***Special Use Permit #2021-00040***  
***4817 Peacock Avenue***

Application	General Data	
Public hearing and consideration of a request for a special use permit, with modifications, to construct a single-family dwelling on developed, substandard lot.	<b>Planning Commission Hearing:</b>	June 24, 2021
	<b>City Council Hearing:</b>	July 6, 2021
<b>Address:</b> 4817 Peacock Avenue	<b>Zone:</b>	R-20/Residential Single-Family
<b>Applicant:</b> Jason R. and Katherine R. Miller, represented by Duncan W. Blair, attorney	<b>Small Area Plan:</b>	Seminary Hill/Strawberry Hill

**Staff Recommendation:** APPROVAL subject to compliance with all applicable codes, ordinances and the recommended permit conditions found in Section III of this report.

Figure 6 - Proposed Site Plan

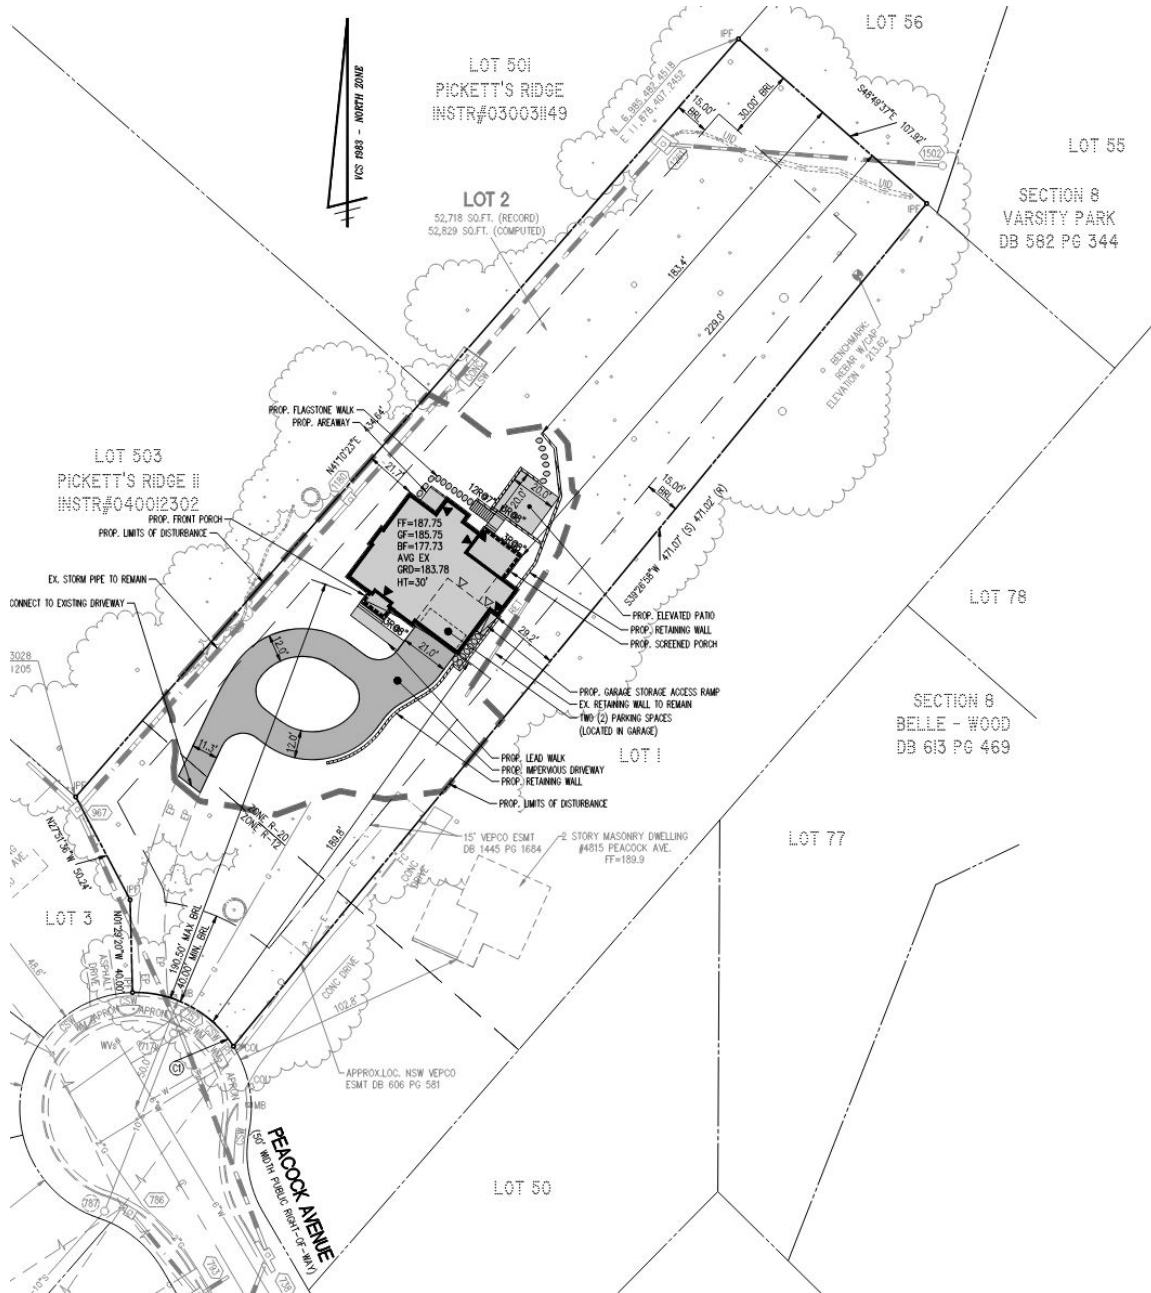
The requested front yard modification would be compatible with the existing neighborhood development pattern as it would allow for the new dwelling in roughly the same location as the existing dwelling.

The requested front yard modification would also be desirable to keep the dwelling as from the street as possible, eliminating any potential impact to neighborhood height, bulk or design compatibility. Further, because the proposed modification would allow for the new dwelling to provide nearly the same front yard that the existing dwelling does, it would minimize the amount of land disturbance and maximize the number of trees to be preserved.

The requested modification from the attached garage setback would also allow for diminished site disturbance. Setting the garage back eight feet would increase the limits of disturbance because the dwelling's footprint would have to be expanded to accommodate the garage setback. The additional setback would also be occupied by additional driveway space that would not be needed under the applicant's current proposal. Staff finds both elements to be environmentally optimal in minimizing the disturbed area of the site, allowing for the preservation of more existing trees and shrubs and limiting impermeable surfaces. This modification would have no impact on neighboring property, as it would not be perceptible from the street nor adjacent properties.

Figure 7 – Proposed tree preservation plan

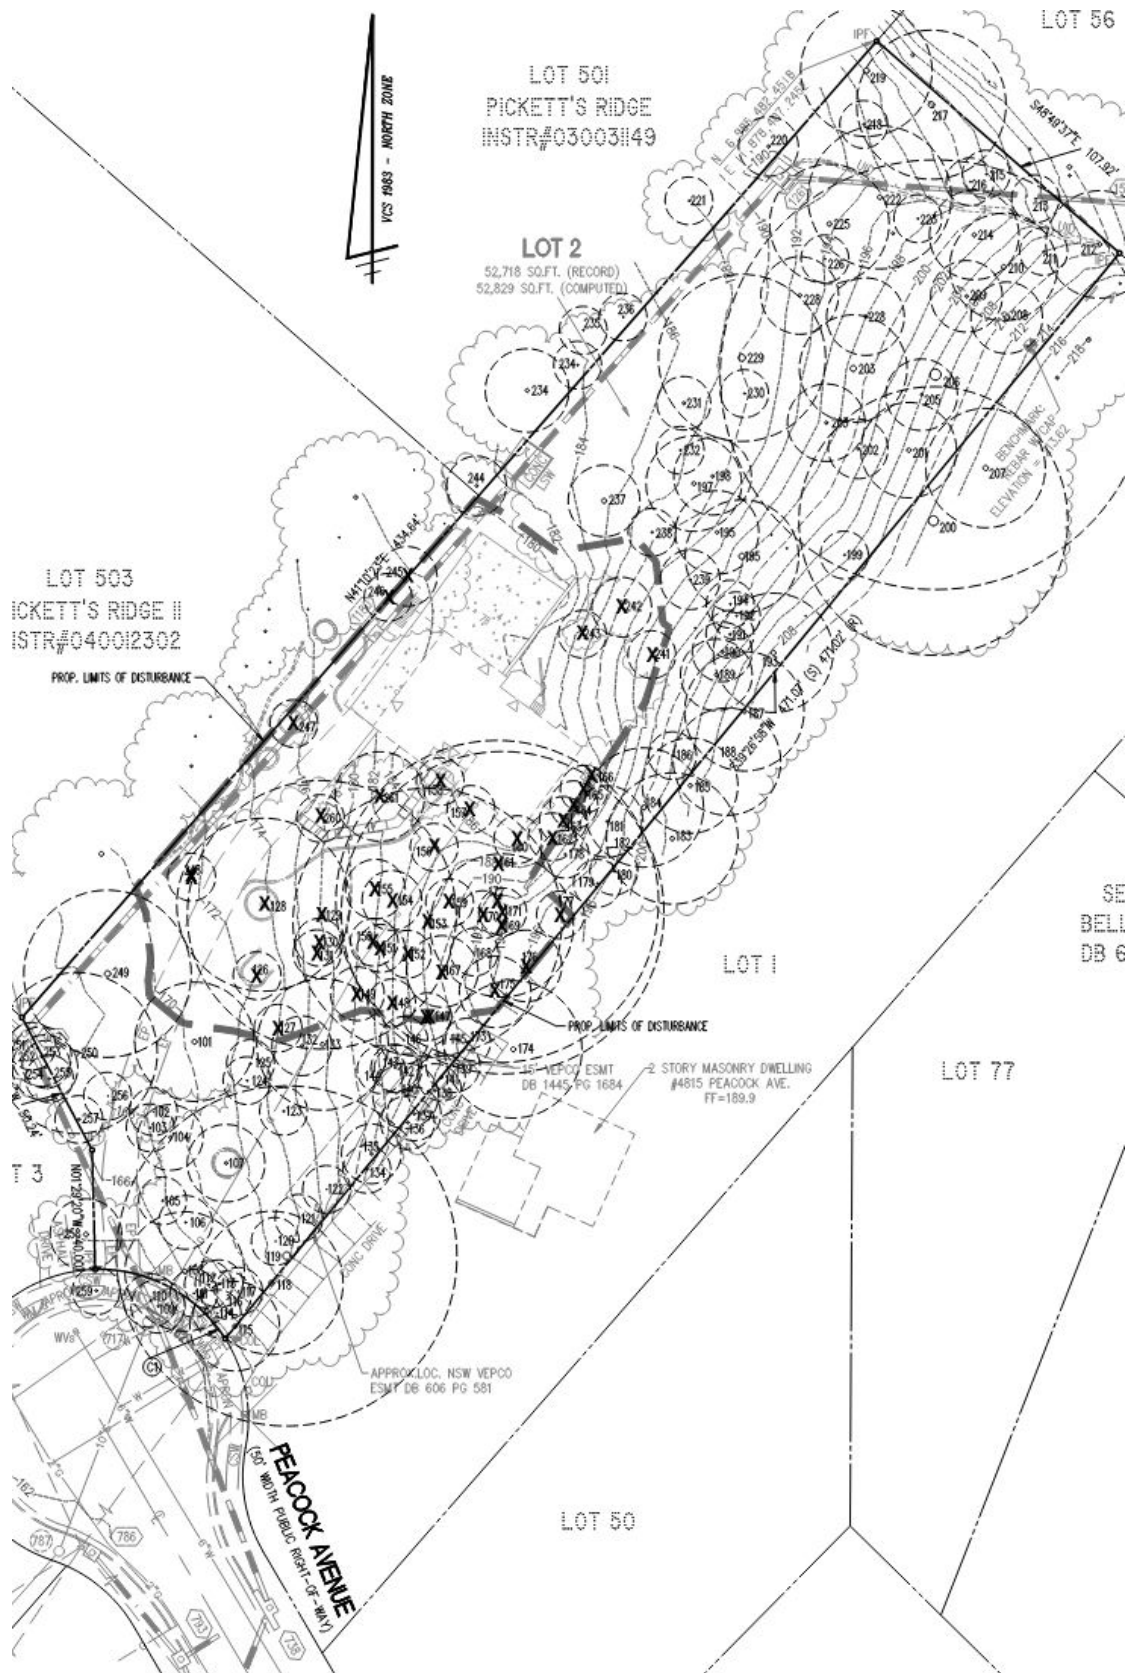
Regarding tree preservation, staff is pleased to see that the applicants intend to maintain many of the subject property's existing trees. In addition to complying with the City's Landscape Guidelines at the future administrative review of the grading plan, staff recommends Conditions #2 and #3 to ensure the existing mature and native trees planned for preservation in figure seven are adequately protected during construction.

2. Minimize the limits of disturbance on the grading submission to the greatest extent possible to maximize the tree protection areas. Where the critical root zone of trees outside of the limit of disturbance overlap with proposed construction, tree preservation measures shall be employed to ensure the survival of roots within the critical root zone where possible. (P&Z)

3. A tree protection plan developed by an arborist shall be submitted with the grading plan to ensure preservation and protection of the following trees: 101, 132, 133 and 249. (P&Z)
